CTS HERITAGE

10 November 2021

RE: PART TWO AMENDMENT FOR THE APPROVED RIETKLOOF WEF NEAR MATJIESFONTEIN IN THE WESTERN CAPE

Map 1: Amended final layout of the Rietkloof WEF

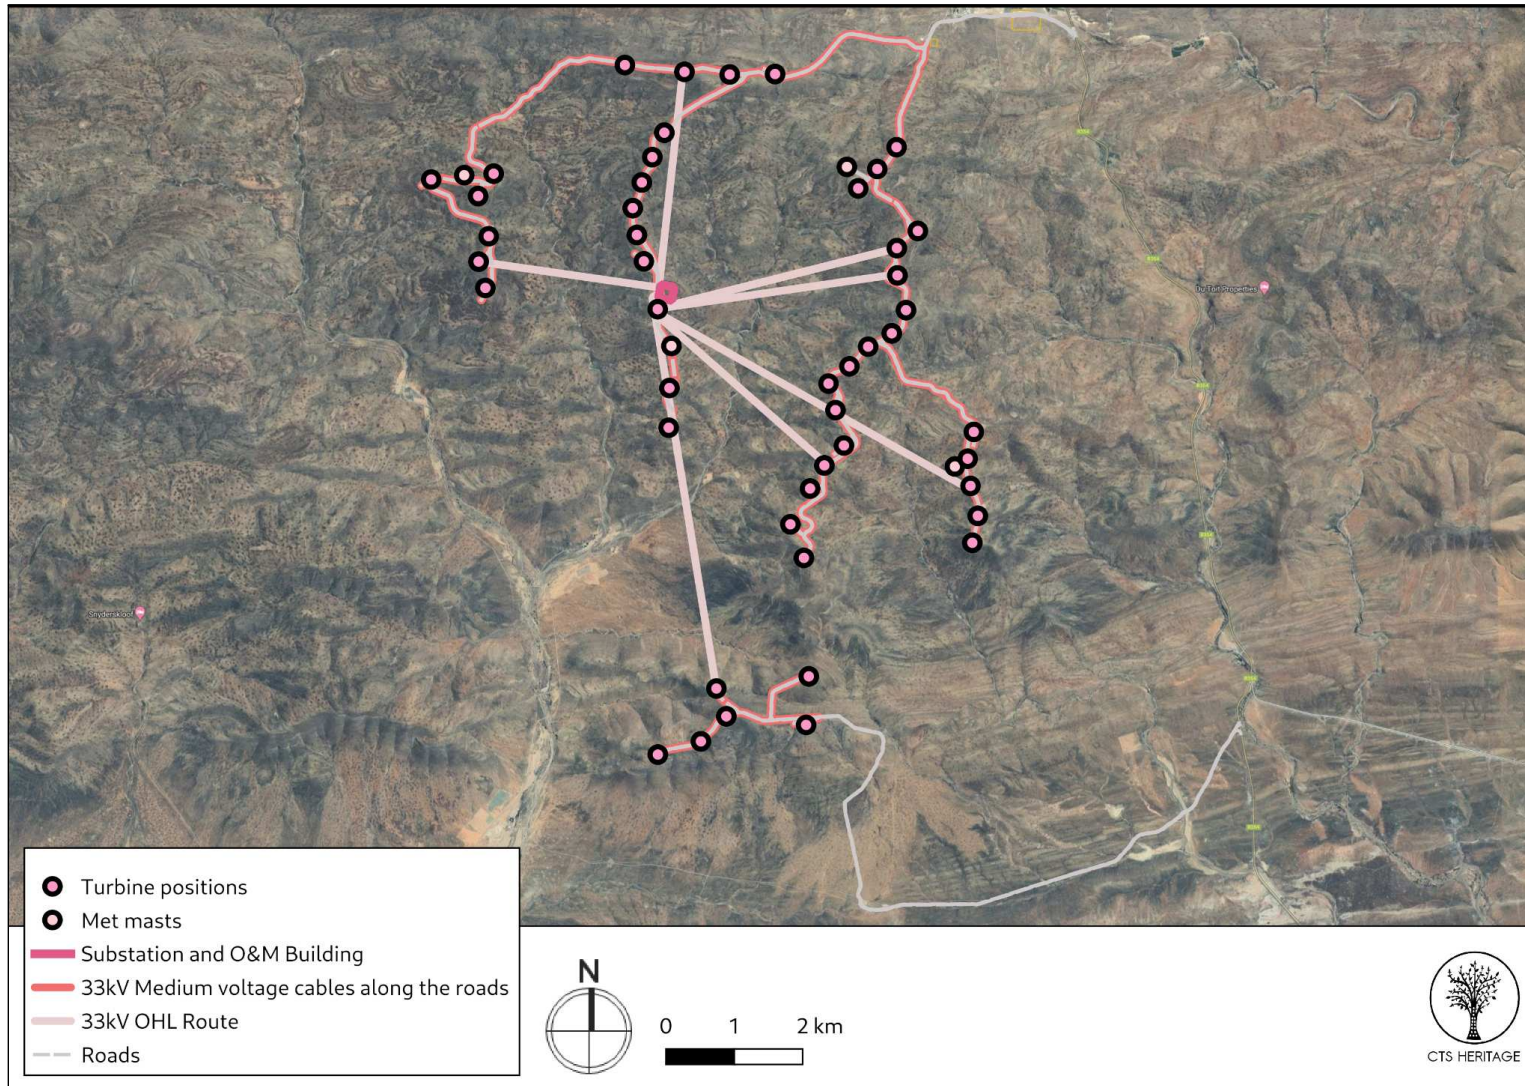
This letter is therefore drafted to confirm that the final amended layout dated November 2021 for the Rietkloof WEF does not impact any known heritage resources and adheres to the recommendations included in the CTS Heritage Walkdown report for this development (September 2021) which concludes that “The final layout for the Rietkloof WEF avoids impact to all known significant heritage resources present within the development area. The walkdown of the final layout revealed no new significant heritage resources that are likely to be impacted.”

Map 3: Track paths followed for the walkdown of the Final Layout

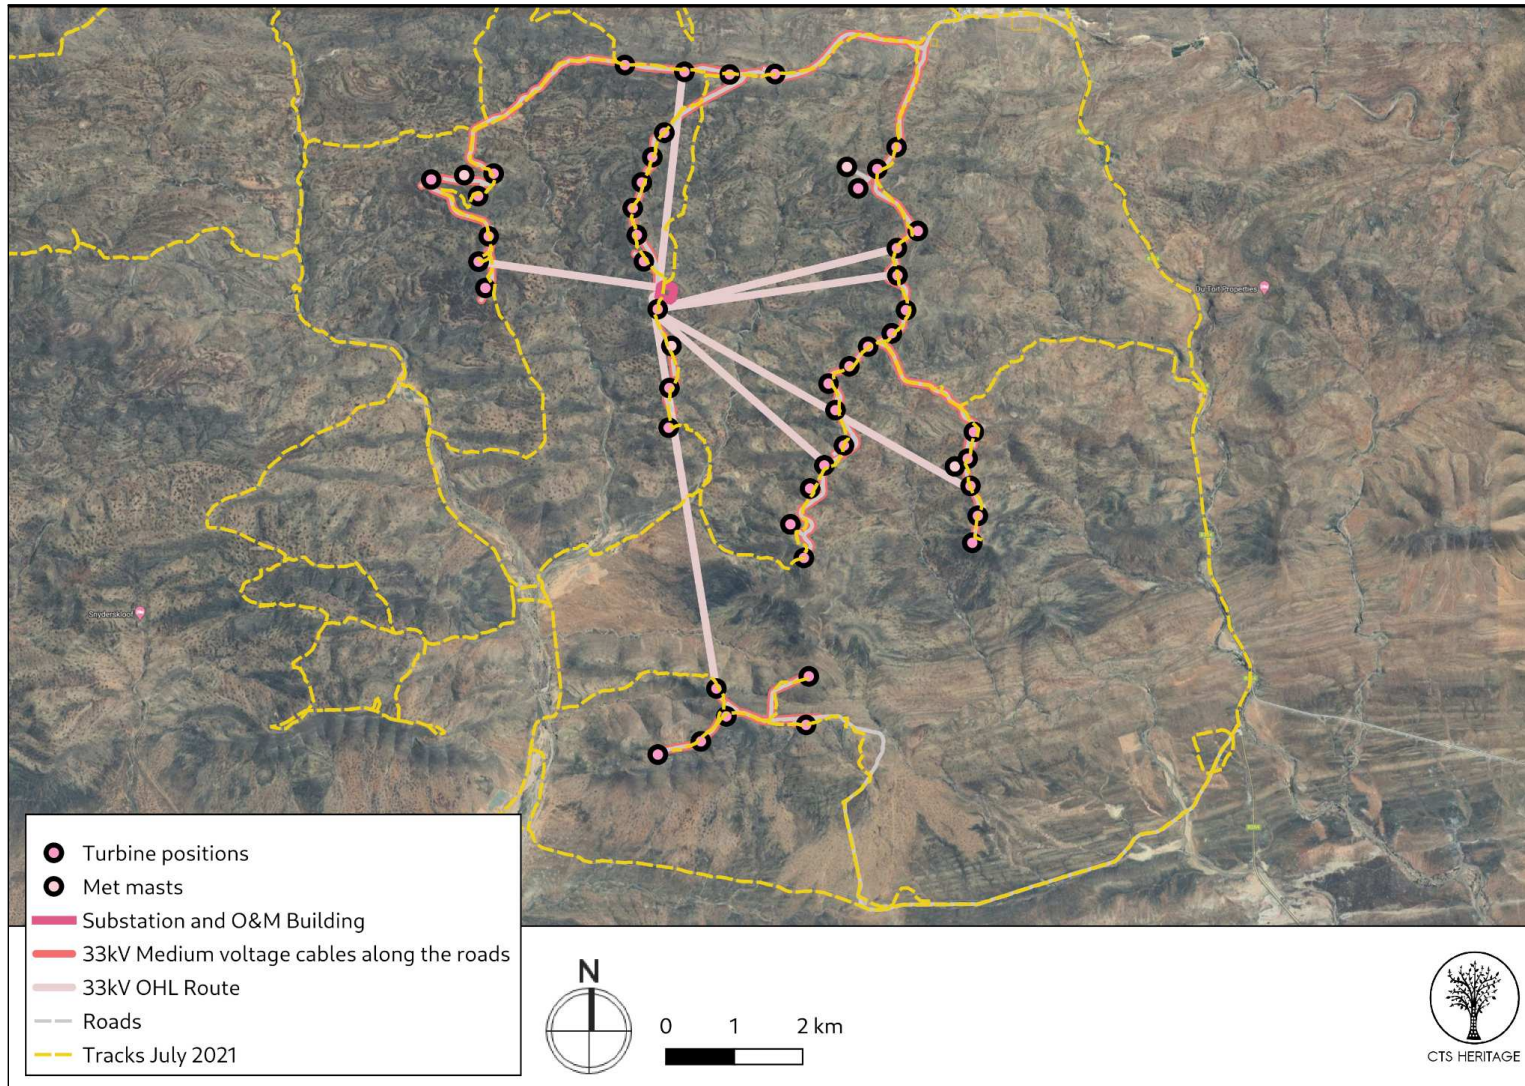
However, please note that the proposed alignments for the 33kV Overhead Lines (OHL) were not assessed as part of the Walkdown process (Map 3). As such, there remains a risk that the construction of these overhead lines may negatively impact on significant archaeological or palaeontological heritage and as such, it is recommended that the proposed locations of the footings for the pylons for the OHL be inspected for such impacts during the construction phase of the development.

Map 4: Known heritage resources overlain with the proposed amended layout (refer to Walkdown Report September 2021 for the Site details)

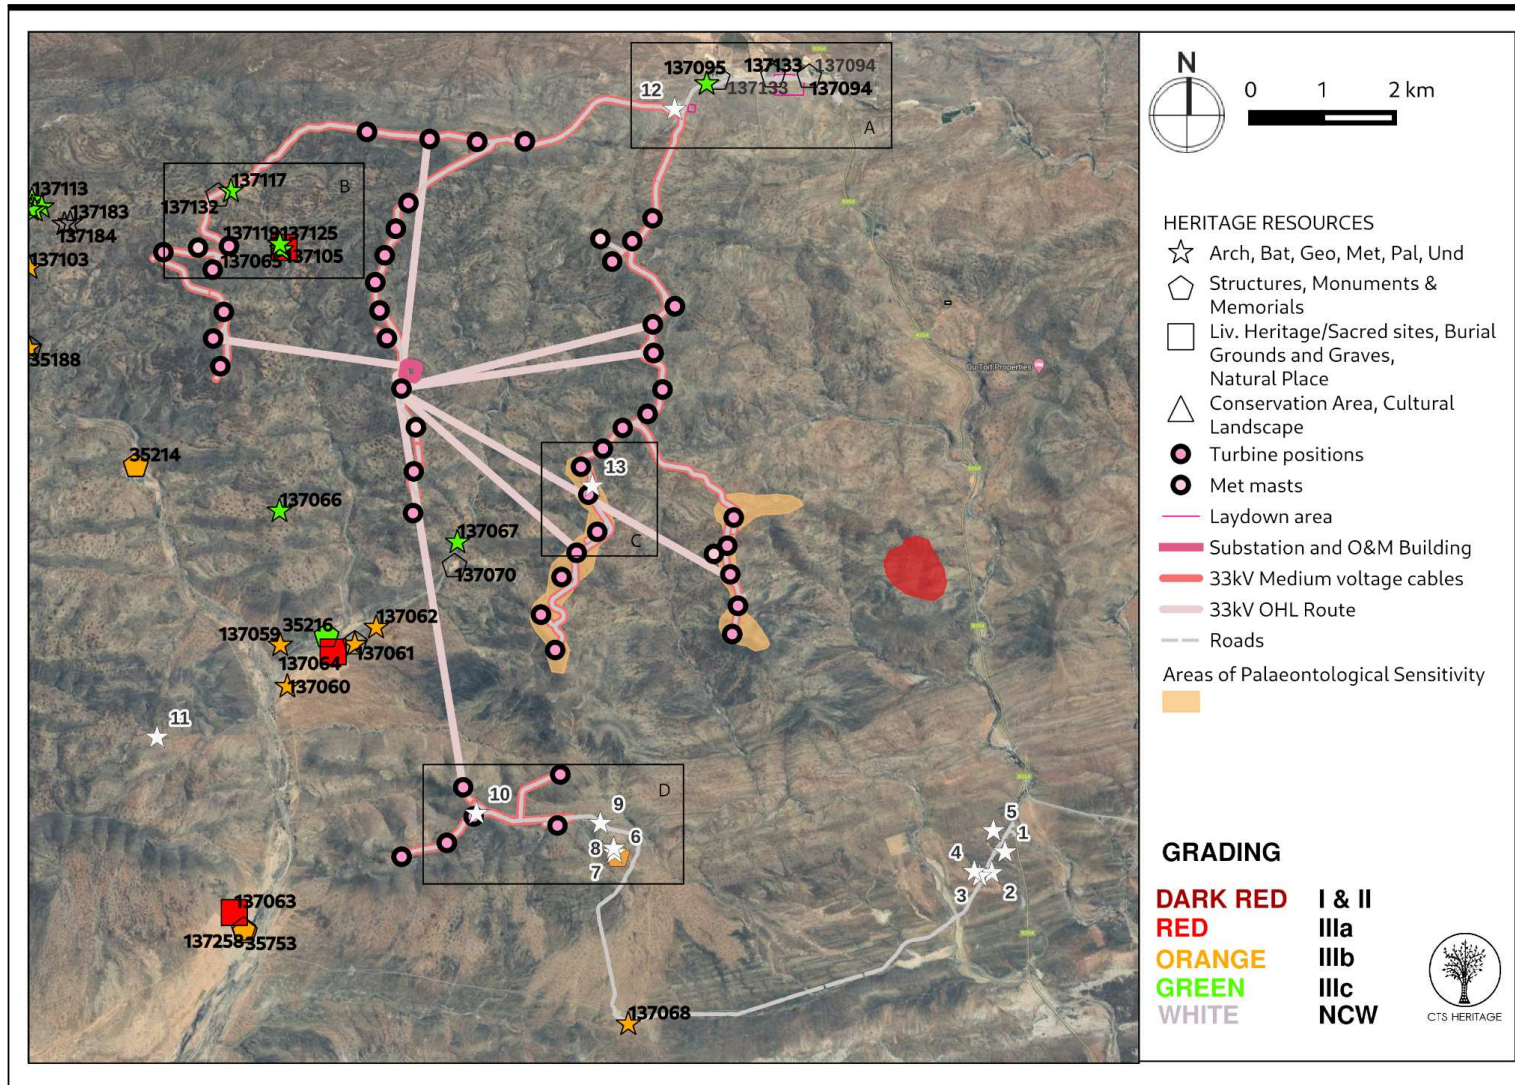
Although the EA did not make any specific conditions pertaining to the conservation of palaeontological heritage, the PIA completed for the Rietkloof WEF recommended that the area marked in Orange in Map 4 should be inspected for fossil wood occurrences by a professional palaeontologist prior to construction. It is recommended that this mitigation step be completed prior to the construction of the turbines in this area.
